DEPARTMENT OF PLANNING & INFRASTRUCTURE

SUBJECT: MODIFICATION TO MOORE COLLEGE STAGE 1 RESOURCE AND RESEARCH BUILDING (MP 09 0007 MOD 1)

Figure 4: Proposed Rooftop Plant Level

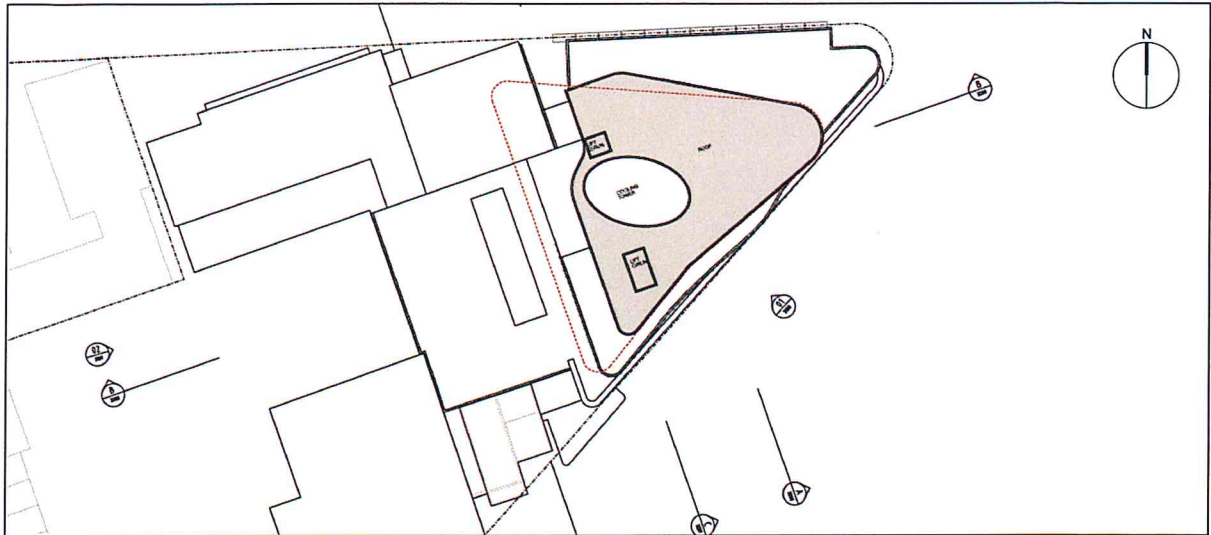
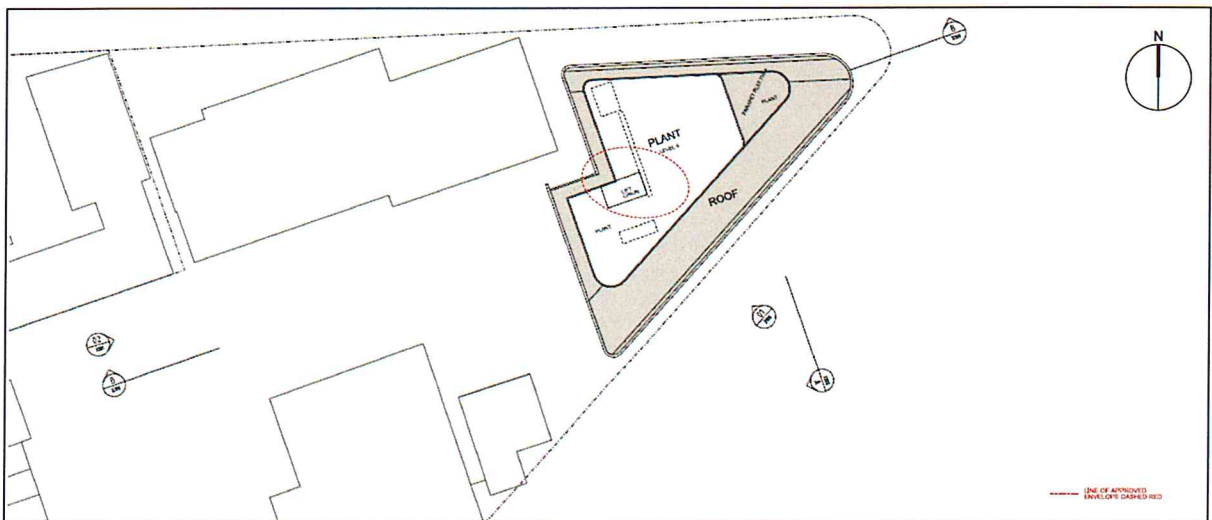
- the bulk and height of the expanded plant room is excessive given the buildings prominent location;
- did not support the proposed removal of two street trees and the proposed loading zone on Carillon Avenue (apart from any temporary construction loading zone); and
- reiterated concerns regarding the vehicle access arrangements for the temporary car park, the minimum soil depths for landscaped areas, pedestrian movement, oversupply of car parking and bicycle parking provisions, which were raised during the original assessment of the concept plan and major project application.

The proposed modifications to the rooftop plant (see **Figures 3 and 4**) will increase the mass of the built form (see **Figures 5 and 6**). The more linear treatment of the building edge on the upper levels to King Street and closer alignment with the site boundary reduces the visual interest in the King Street elevation, which also increases the prominence of the rooftop plant. Council supports the revised design of the building and considers it to be compatible with the surrounding environment, however, considers the size of the plant to be excessive.

The department notes that the plant was previously largely located in the basement levels and has been relocated to the rooftop, resulting in the deletion of two basement levels given the removal of the ASRS. The storage space within the remaining basement level has been converted to a lecture theatre. The department considers that it would be unreasonable to require the proponent, a non-profit educational establishment, to construct costly basement structures for the sole purpose of plant as the larger basement structure required for the ASRS has been removed from the project. Furthermore, the modified building continues to comply with the prescribed height limit in the concept plan (maximum RL 70.6) and the rooftop plant is set back from the façade of the building and will be enclosed using aluminium louvres.

The department considers the relocation of the plant acceptable within the context of the site as it has been positioned to minimise visual impacts to the King Street and Carillon Avenue gateway. Therefore, the department considers the design modifications to the Stage 1 Resource and Research Building acceptable.
